SERVICE INSTRUCTION FOR IMPROVED TIGHTNESS, VALID FOR ALL MICROWAVE COMPACT APPLIANCES, BEGINNIN IN 2005 UNTIL S.N. 2 36 30249

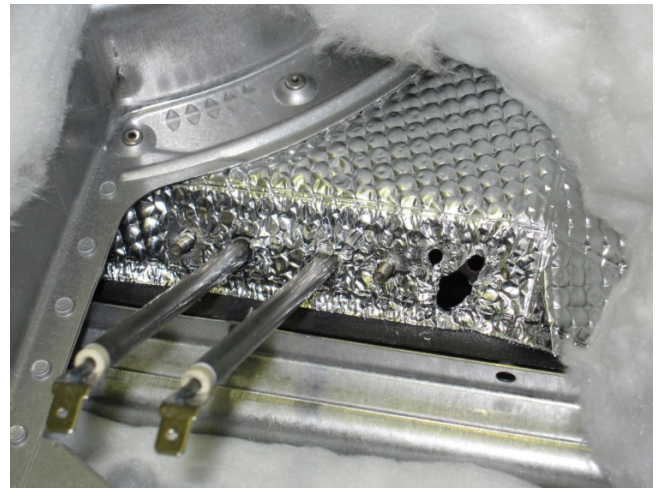
State of origin, white insulation carefully pushed aside.

Loosen nuts for L-flange and PT500 sensor (will be used again). Remove L-flange and pull cable of the PT500 sensor carefully through the cavity hole.

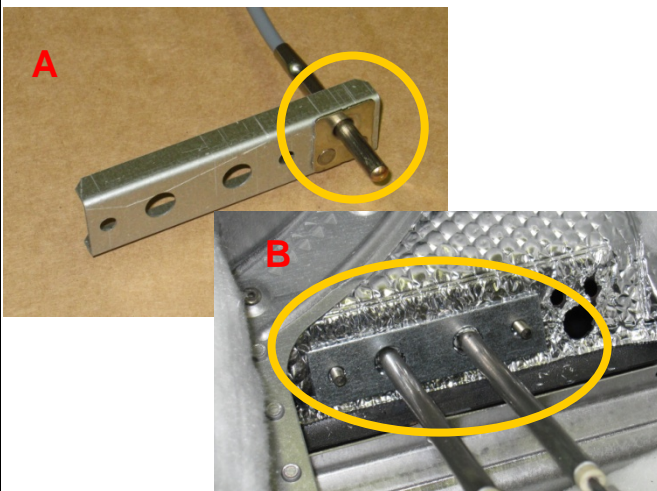
Fix the PT500 sensor on the new **U-flange (A)** and place the new **flat plate (B)** over the heater connections on the cavity.

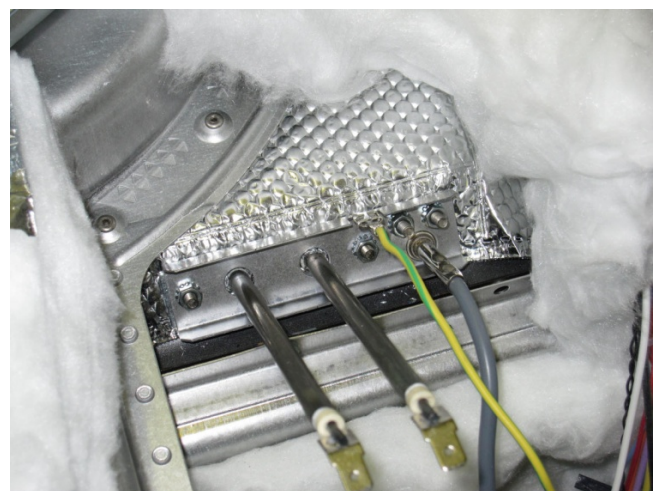
Bring the new **U-flange** with the PT500 Sensor over the heater connections on the cavity and screw it. Important, no overlapping of **flat plate** and PT500 flange is allowed.

IMPORTANCE / ACCURACY

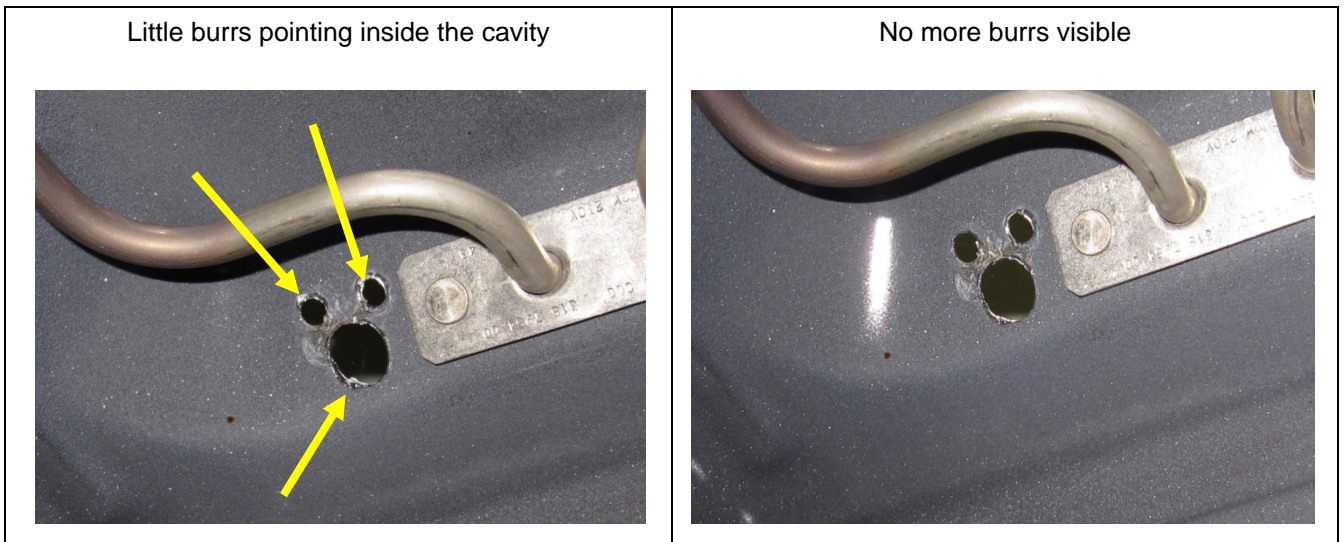
- Prior to the assembly of the new **U-flange**, all remaining leavings of the aluminum gasket, pointing inside the cavity needs to be removed thoroughly. This is to ensure no further discharges on these leavings. As a spare part, the gasket **315 84 31-00/1** is to be used.
- The aluminum gasket needs to be in good shape. No tears, cracks and folding are allowed; otherwise the limit of the microwave radiation will be considerably exceeded.
- During the assembly of the **U-flange**, overlapping of **flat plate** and PT500 flange is absolutely to be avoided. Any overlapping results in considerably exceeded the limits for microwave radiation.
